**ADDRESS: 1830 RITTENHOUSE SQ, UNIT 6A**

Proposal: Replace Windows

Review Requested: Final Approval

**BACKGROUND:**

5 EXISTING WINDOW F

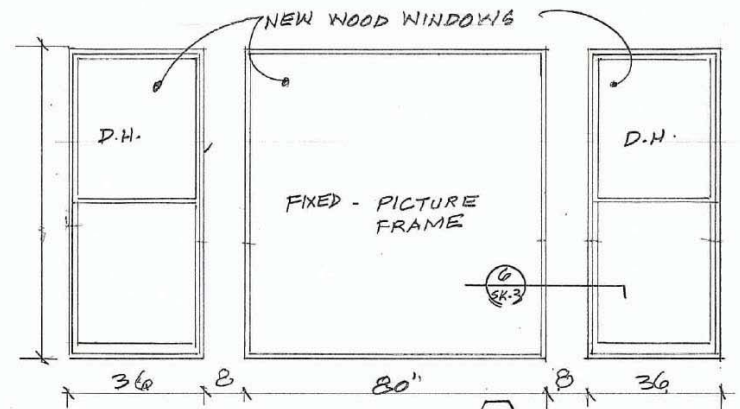
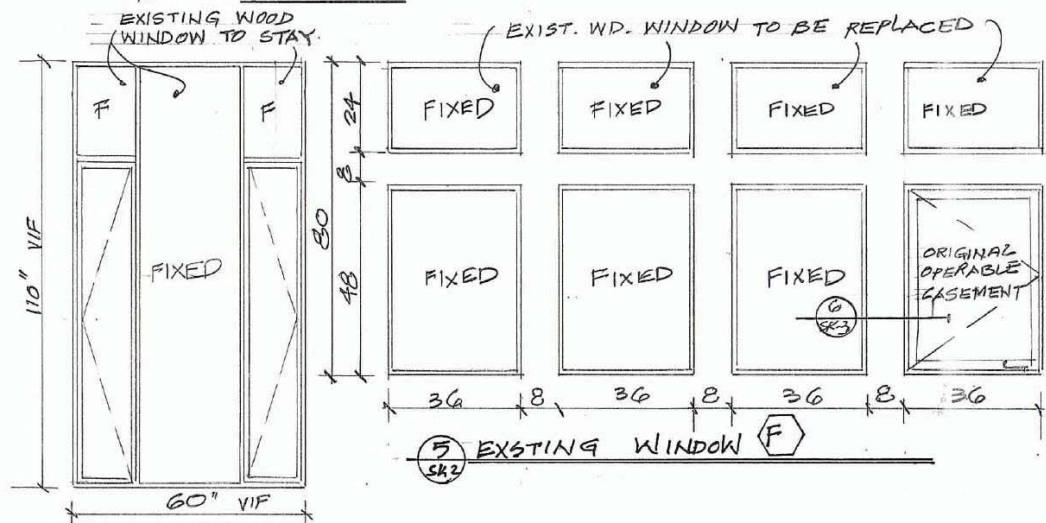
- The Architectural Committee noted that many windows are shown on the drawings and questioned which windows are included in the current application. The Committee asked whether the transoms will be removed. The Committee members expressed confusion because the application includes drawings of the front as well as the side and rear windows.

- Mr. Kane responded that, although they propose to replace side and rear windows at a later date, only the front window marked “F” on the drawings is in question today. He noted that they have shown alternates that either remove or retain the transom windows on F.

- Mr. Rosen explained that they would be willing to retain the two side windows and even retain the transom at “F,” but that they would like to remove the wide central mullion.

- Mr. Detwiler noted that the window in question is quite visible and sits within a decorative masonry frame on the facade, making it one of the chief areas of significance on this façade.

- The removal of the original architectural window features in either alternate proposal does not meet Standards 2 and 6.

**ARCHITECTURAL COMMITTEE RECOMMENDATION:** The Architectural Committee voted to recommend denial of the removal and replacement of original front windows, pursuant to Standards 2, and 6.

2 NEW PROPOSED WINDOW (G)  
 (1) REQ'D

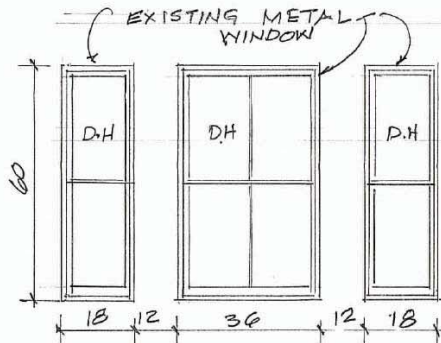
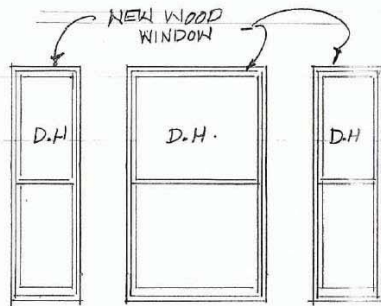
A unit owner proposes to replace windows in this condominium building. The owner proposes to remove eight historic windows (F) with the large wood mullions on the front façade and install picture windows without mullions. In 2002, the Historical Commission approved the same project for the same owner for a unit on the 15<sup>th</sup> floor. The owner is now moving from that unit on the 15<sup>th</sup> floor to the unit in question on the 6<sup>th</sup> floor and would like to recreate the window configuration. During the 2002 review, the owner pointed out that several units in the building have picture windows without the wood mullions. Those units may have been modified before designation or without the Historical Commission's approval. In 2002, both the staff and the Architectural Committee recommended against removal of the historic windows, contending that the project failed to meet the Secretary of the Interior's Standards. However, the Historical Commission approved the alteration. This time, the windows slated for replacement are more visible from the street because they are on a lower floor. The application also proposes to remove several vinyl and metal windows on the side facades of the building and replace them with one-over-one wood windows. The removal of the metal window (G) in wood on the side façade may not meet the Standards because the metal window is likely original.

**STAFF RECOMMENDATION:** Approval of the restoration of most side windows; denial of the removal and replacement of original front windows, pursuant to Standards 2, and 6.
